Subject: Gen2 Electronic Clutch Actuator (ECA) Interference

Document Number: TAIB0862

Subject: Gen2 Electronic Clutch Actuator (ECA) Release

Document Number: TAIB-0861

Gen2 ECA (New)

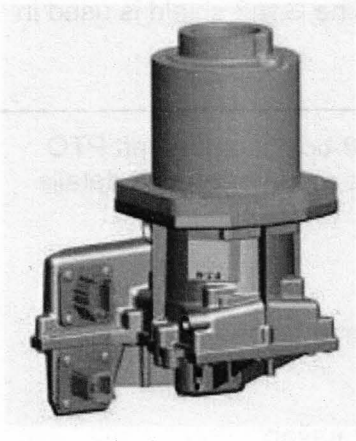
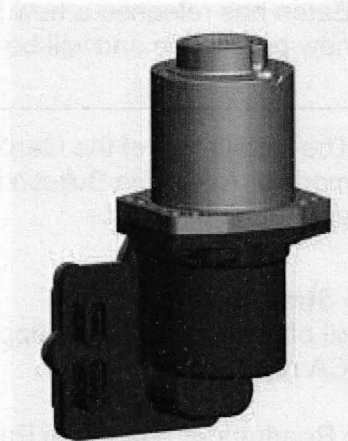
Description: The new Gen2 ECA is being released to production.

The Gen2 ECA introduces a new motor with Deutsch Connectors, and a redesigned shield that surrounds the ECA. The new shield maintains protection for the ECA while enhancing connector accessibility. It also allows for direct, straight alignment of the connector and harness thus eliminating potential side loading of the connector by the use of a separate harness retention bracket mounted directly to the ECA. Two tie-wrap locations on the harness retention bracket are provided to secure the power harness as it is routed in the vehicle.

An all-aluminum enclosure provides improved reliability through enhanced sealing capabilities. The new connectors provide positive locking features with a secondary lock system to improve connection integrity.
